Dear Editor and the reviewers,

General comments

The critical role of uncertainty in projections of hydrological extremes

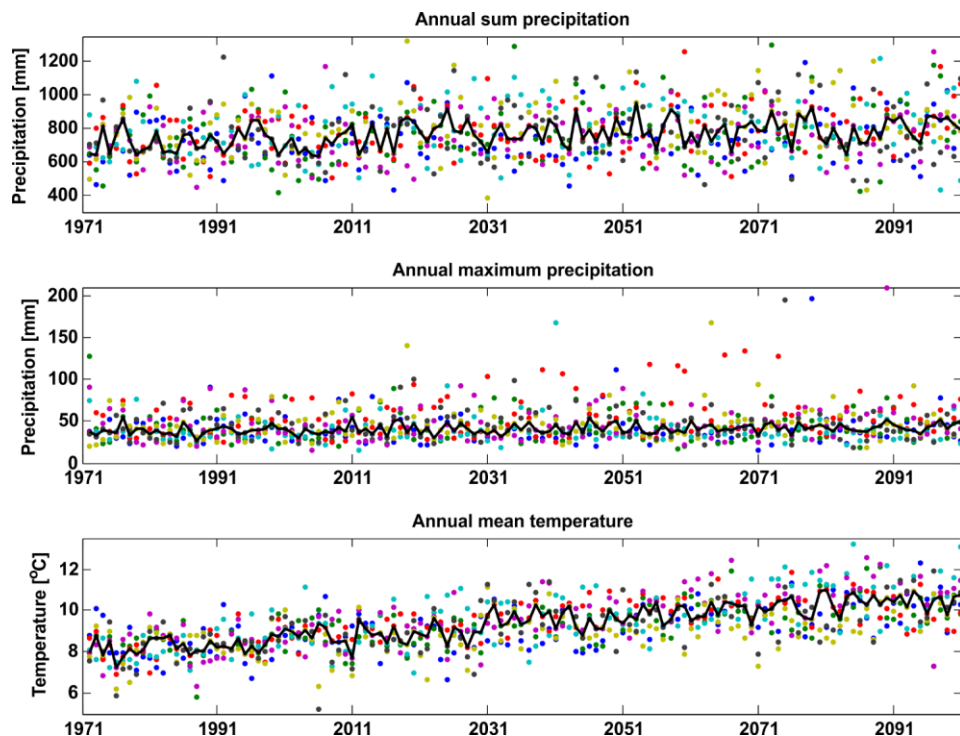
RC16. P10, L4-6: I would still recommend to plot the individual model results in this figure, seven model combinations/ points do not justify the use of a box plot. In the caption it should be ‘annual mean temperature’ instead of ‘annual maximum daily temperature’.

RC18. P10, L10-12: The increase of the temporal variability with time is not very clear from Figure 2.

AR16. Thank you. It is corrected in the main manuscript. Changed ‘annual maximum daily temperature’ to ‘annual mean daily temperature’. However, we are not convinced that that change gives more clear picture of annual extremes.

AR18. We changed this sentence to: “The results show a visible increase of the annual mean temperature and mean values of annual sums of precipitation and annual maxima.do not show visible changes with time.”

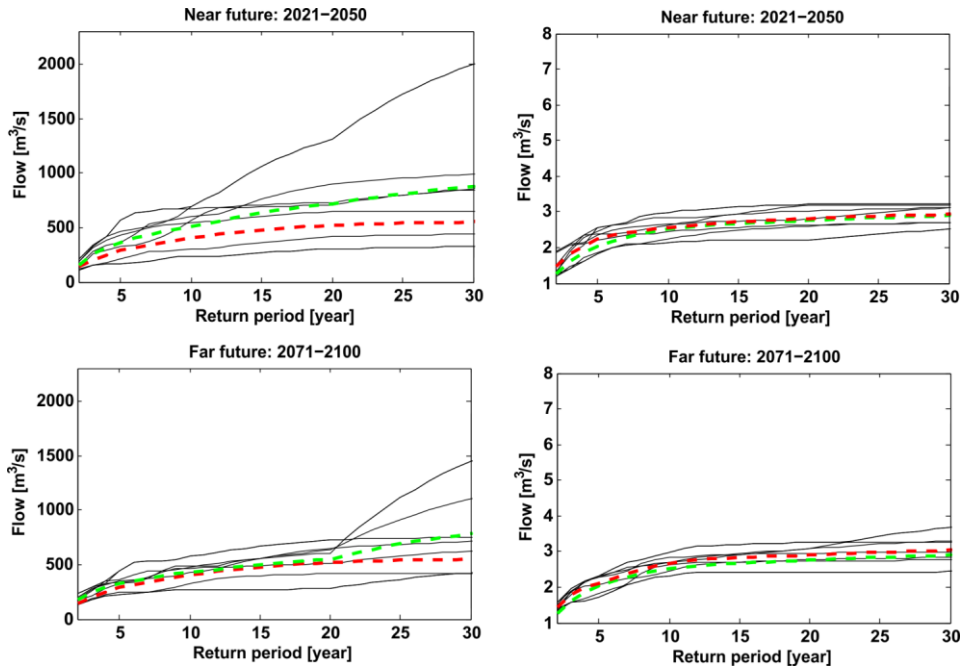
RC20. P11, L20-25: The changes in annual minimum flows are also relatively smaller than the changes in annual maximum flows (see Figure 5). This can be clearly seen from this figure since the range of quantile values for the reference period is approximately the same for low and high flows.

AR20. We agree with the reviewer that the changes in annual minimum flows are relatively small. The text was corrected.

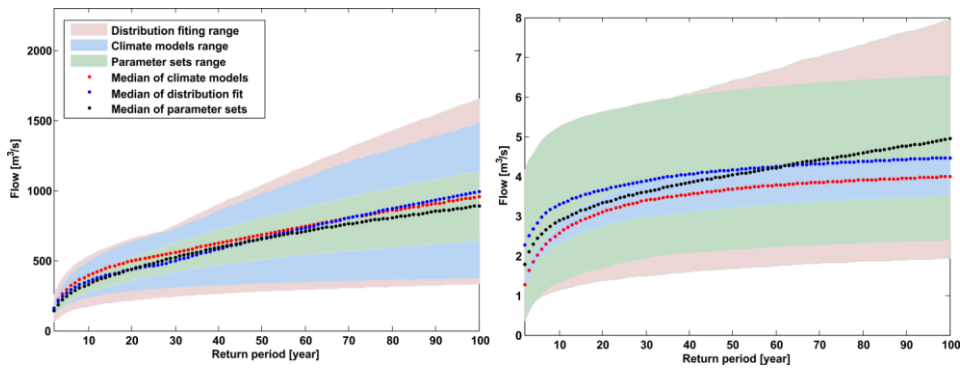
RC 22. P12, L28-31: How should we read Figure 7? Are the different colours overlapping or additive? And how should we interpret the different points?

AR 22. The colours in Fig. 7 are additive. The description was given in the text (page 13, lines 12-14) : “The red dotted lines denote the median of climate ensembles, black dotted lines denote the median of hydrological model parameter sets and the blue dotted lines denote the median related to the GEV distribution parameter fit.”
